Noncompliant Weld Inspection Techniques

Line 114 Non Destructive Examination Final Report

Issue Date December 5, 2013

Weld 771 cited for indications of internal undercut from 12-24

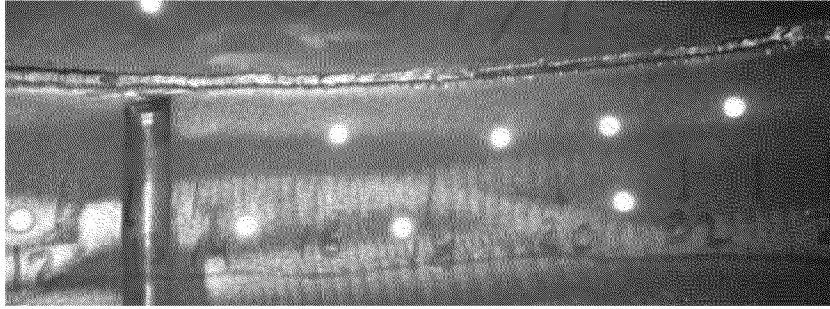
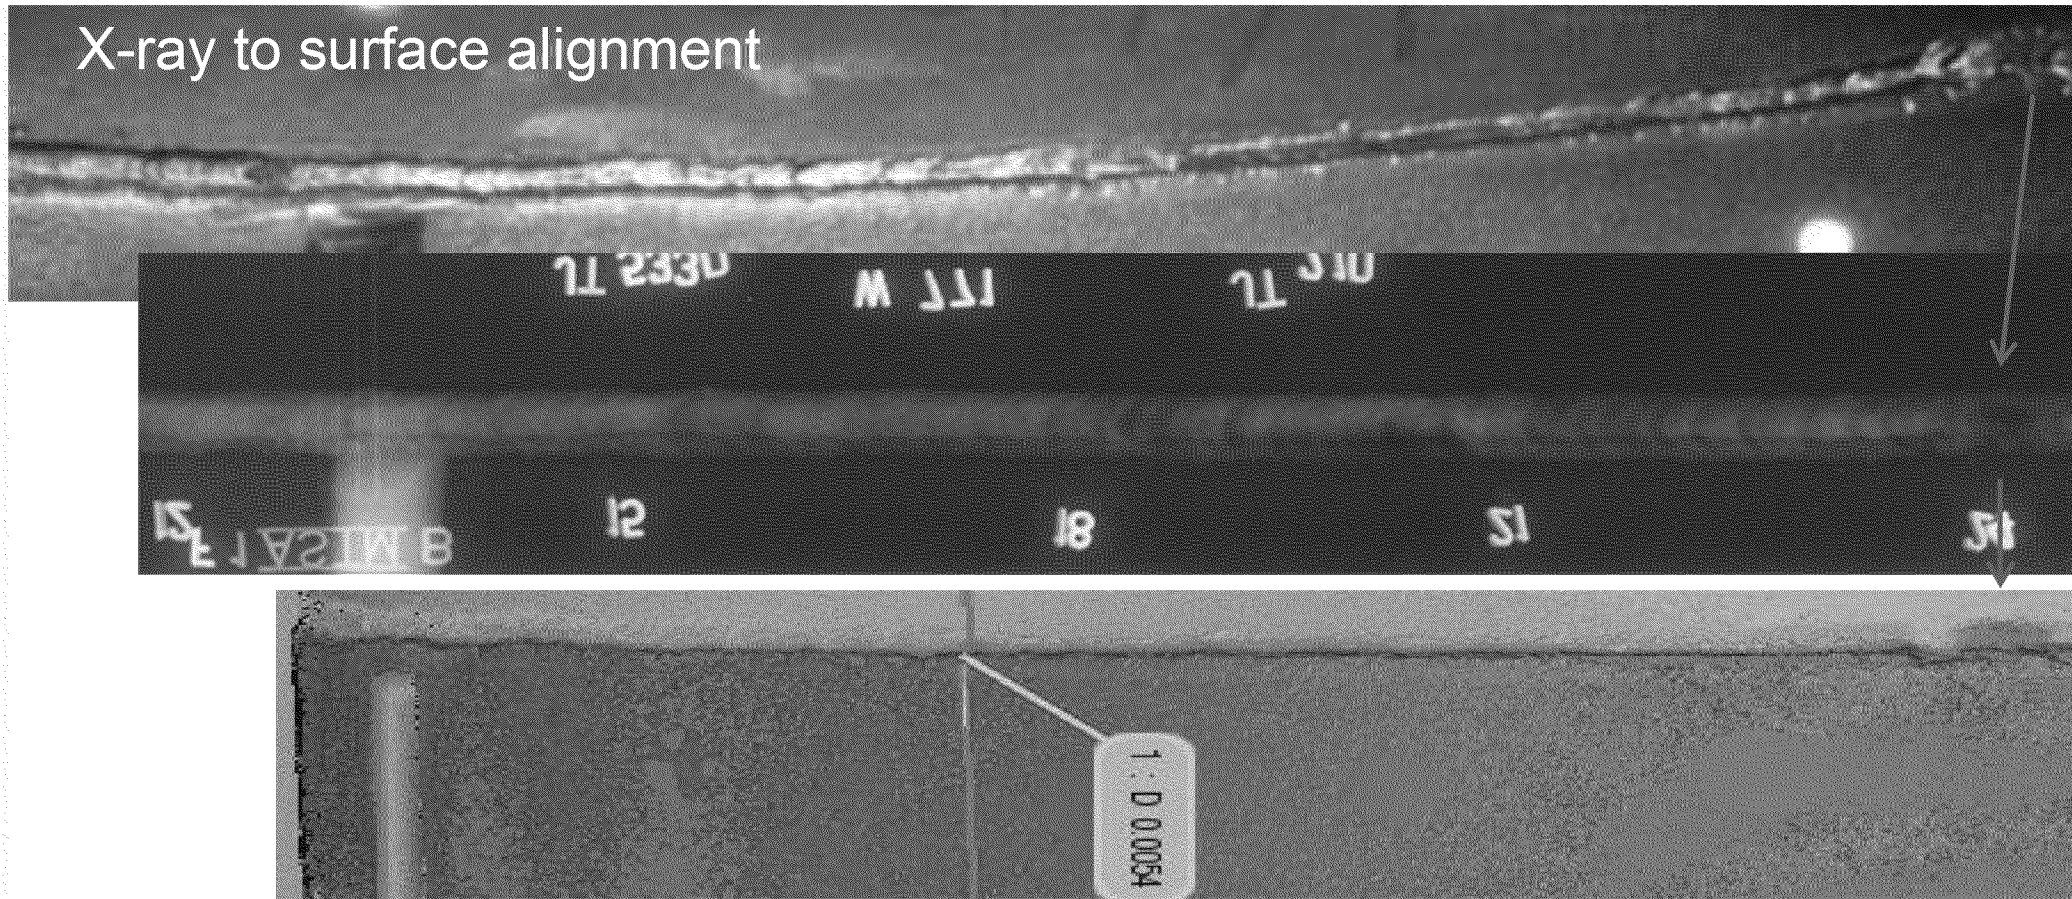
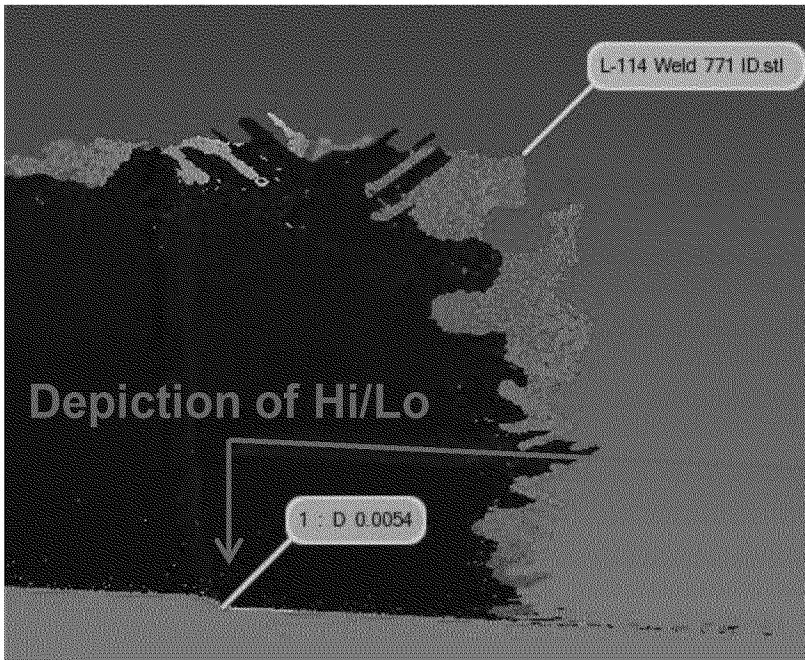
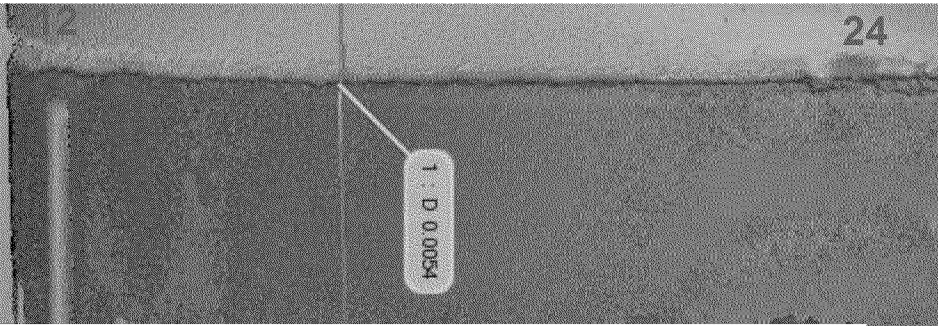
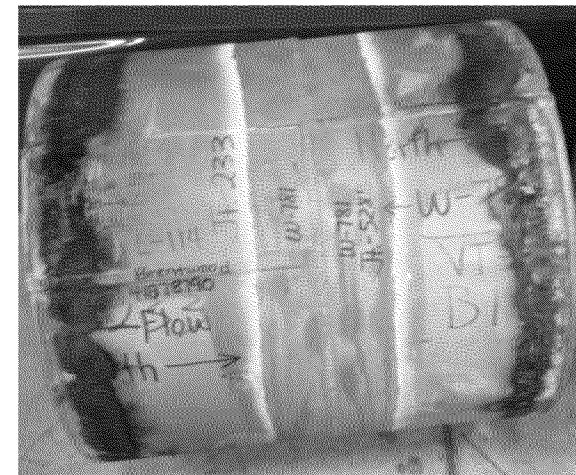
RT estimated depths of up to 0.008 inches

- Confirms indications are mostly diffraction effects on minor hi/lo condition with 0 UC
- Deepest region along length is 0.006 inches
- Weld is acceptable per API 1104

- * Confirms UC indication is diffraction/"shadowing" from high/low condition
- * Weld is acceptable per API 1104

Weld 781 cited for indications of internal undercut from 44-49

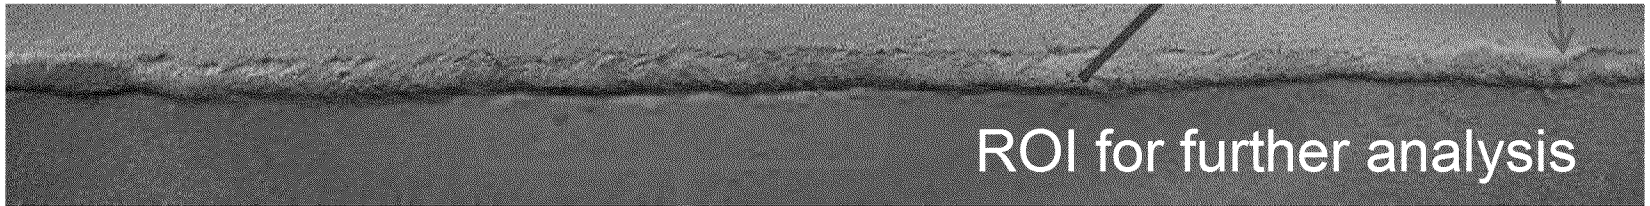
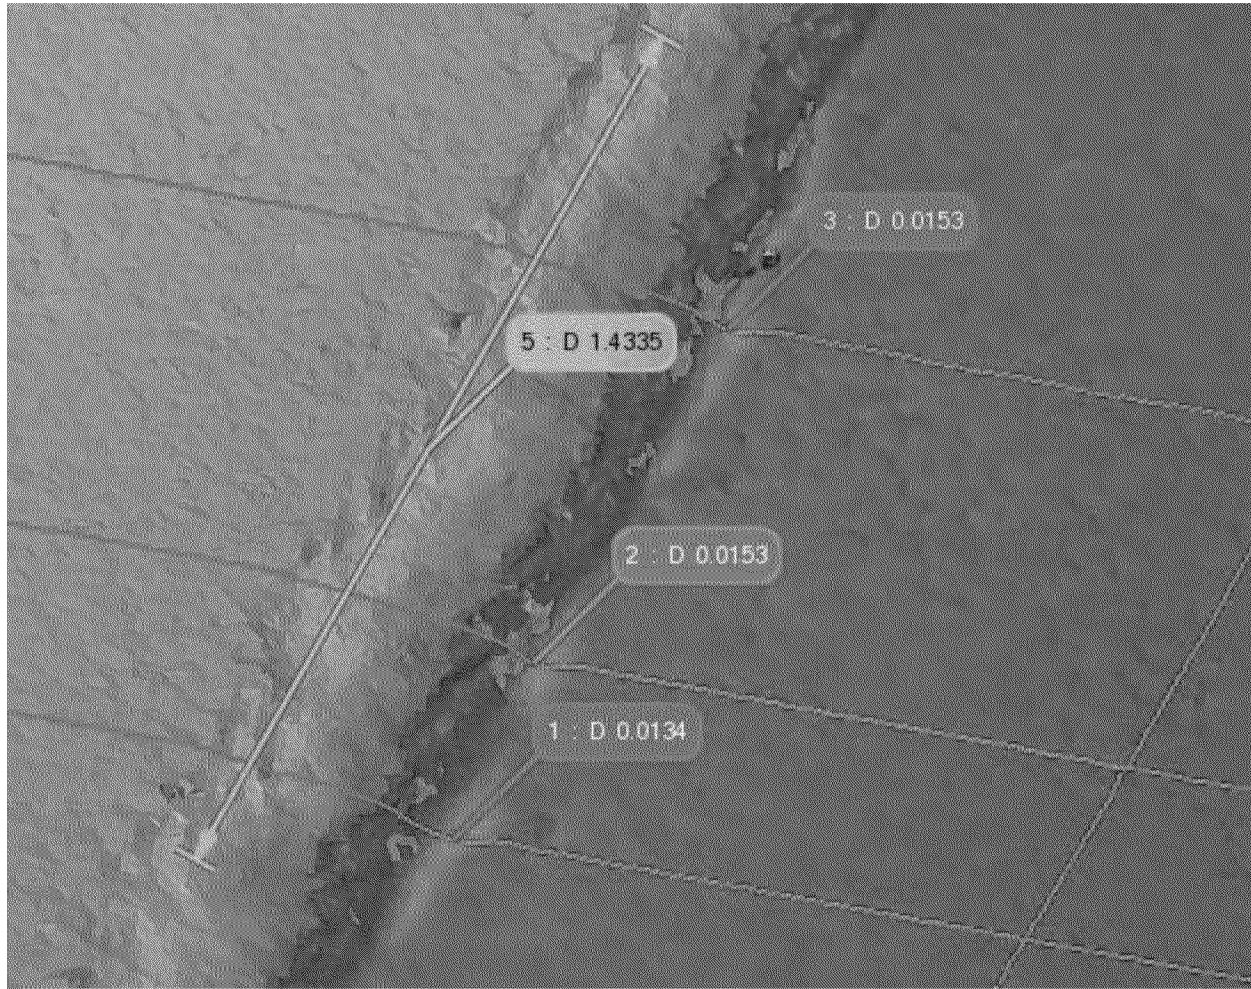
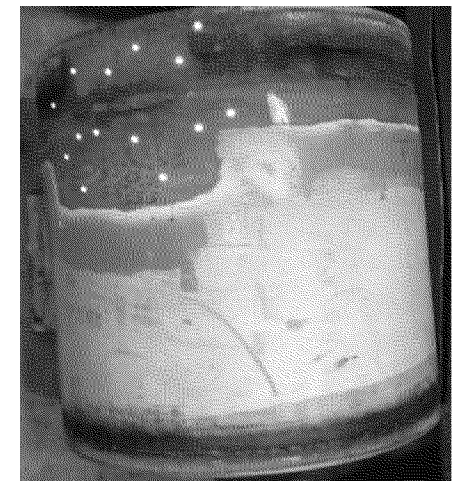
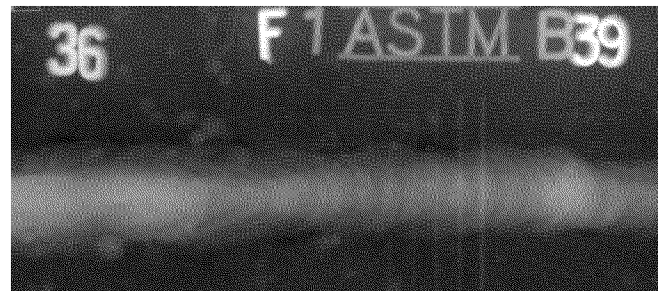
Confirms indications are mostly diffraction effects on minor hi/lo condition with 0 UC

Largest region is 1.5 long x up to 0.015 inches deep

- * Confirms UC indication is, in the majority, diffraction/"shadowing" from high/low condition with less than 2 inches of up to 0.015 inches deep IUC
- * Weld is acceptable per API 1104

Weld is acceptable per API 1104

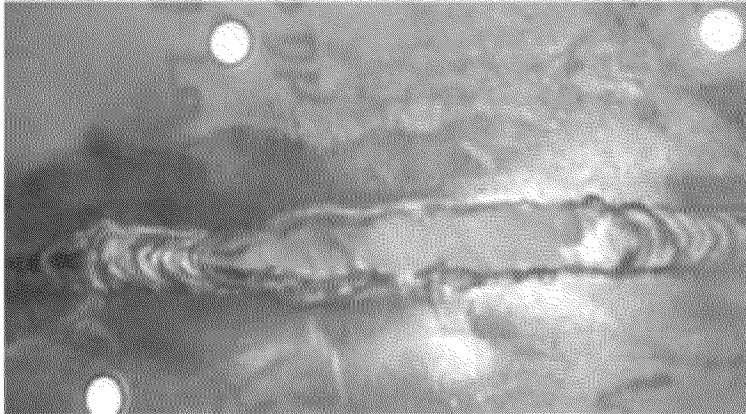
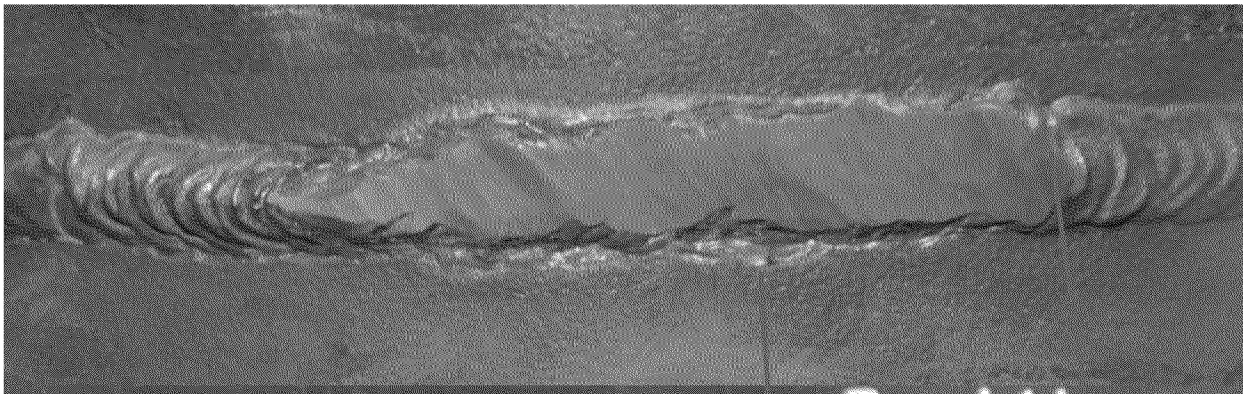
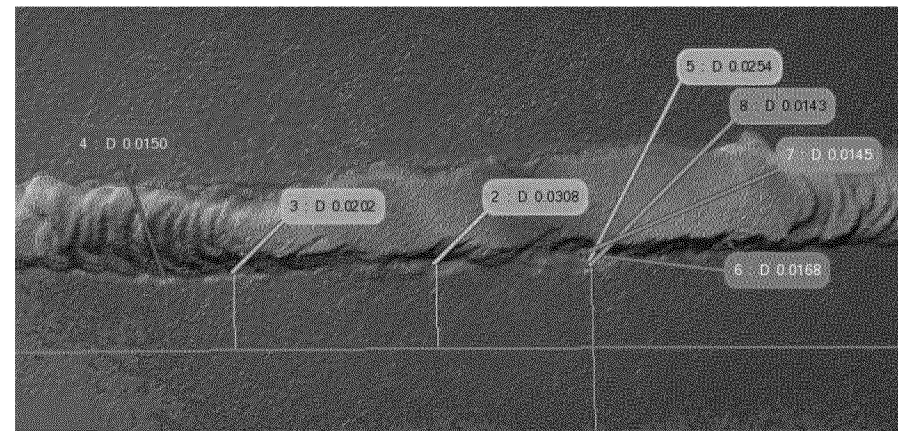
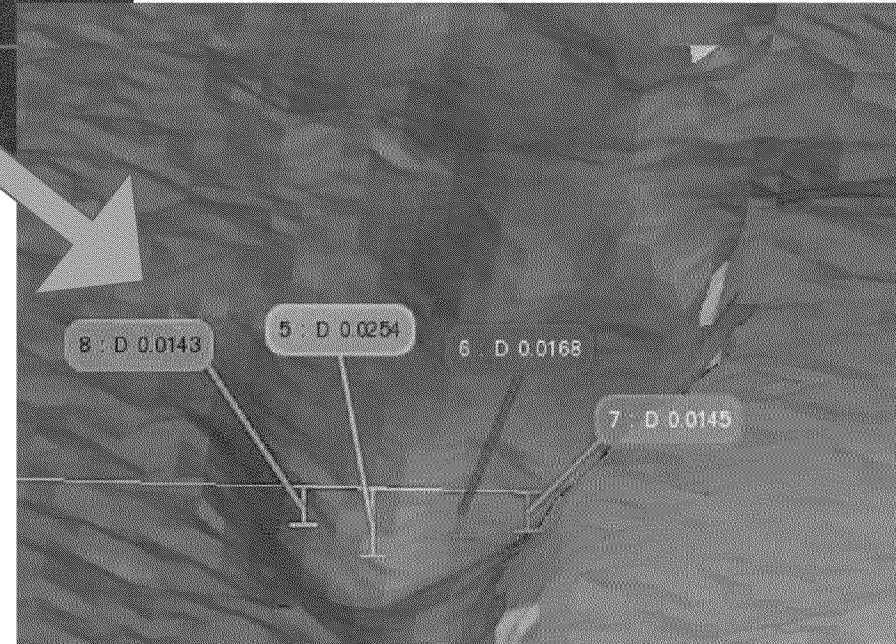
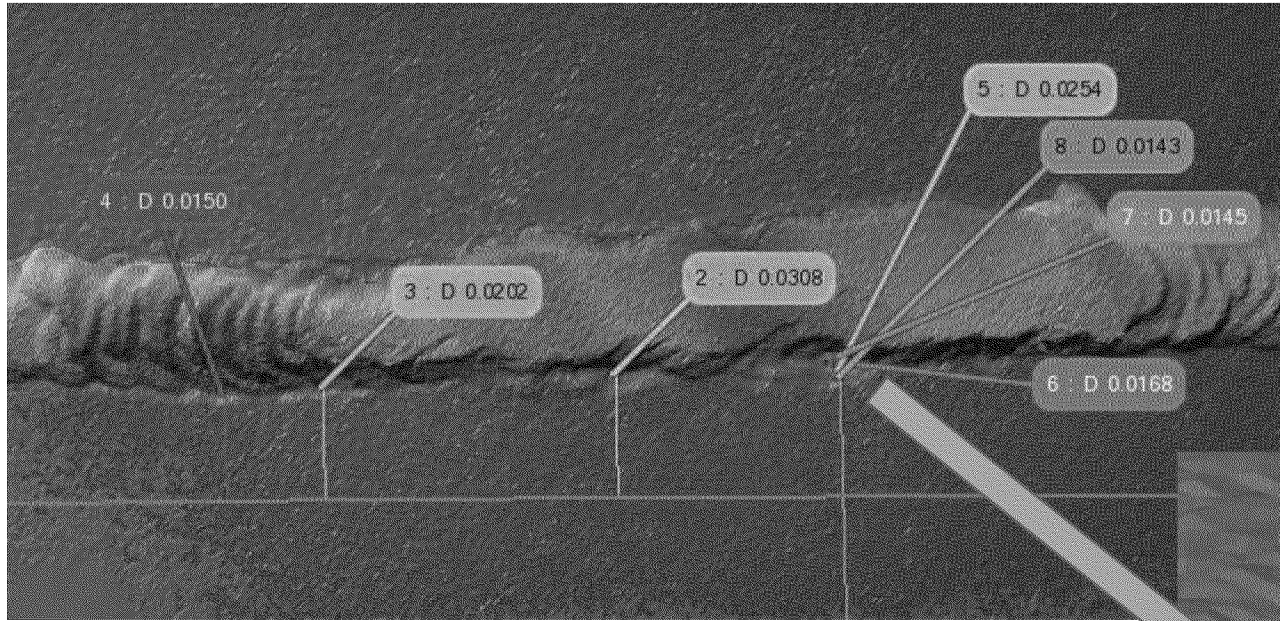
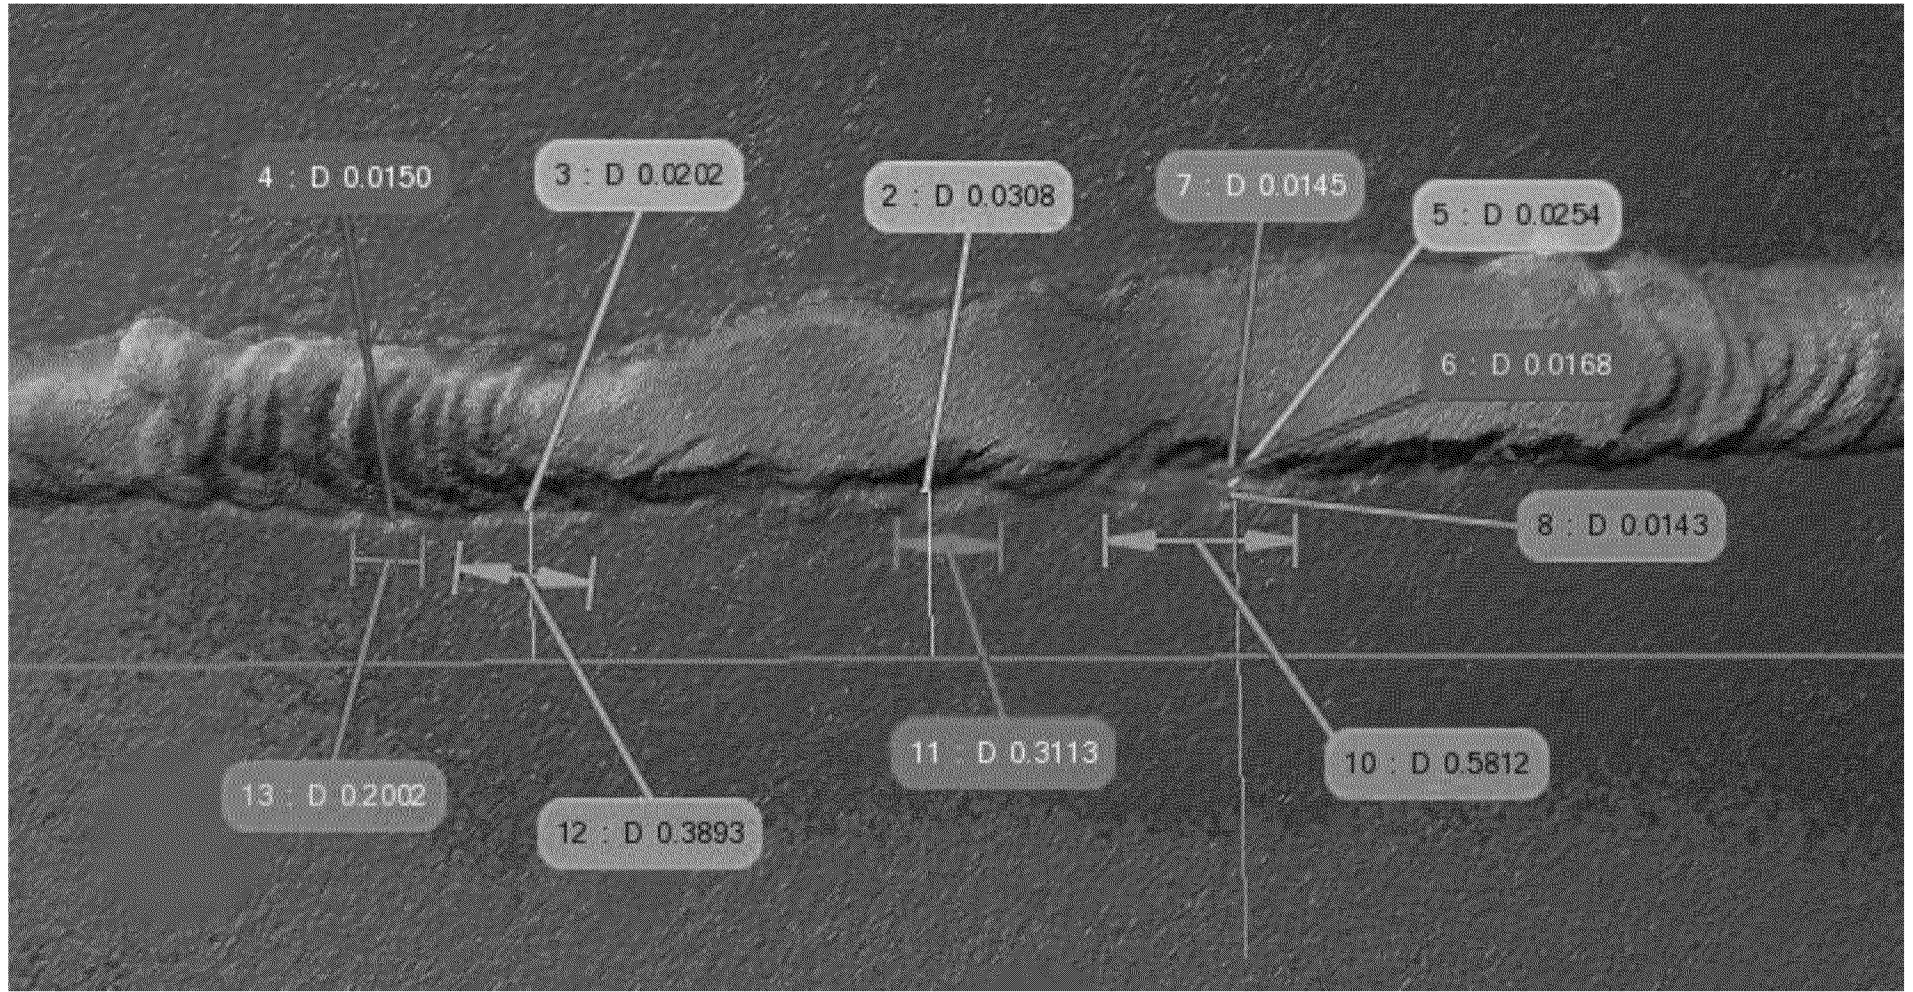
RT estimated depths of up to 0.030 inches

External undercut identified up to 0.030" deep

Sum of UC lengths < 1.5"

Weld is acceptable per API 1104
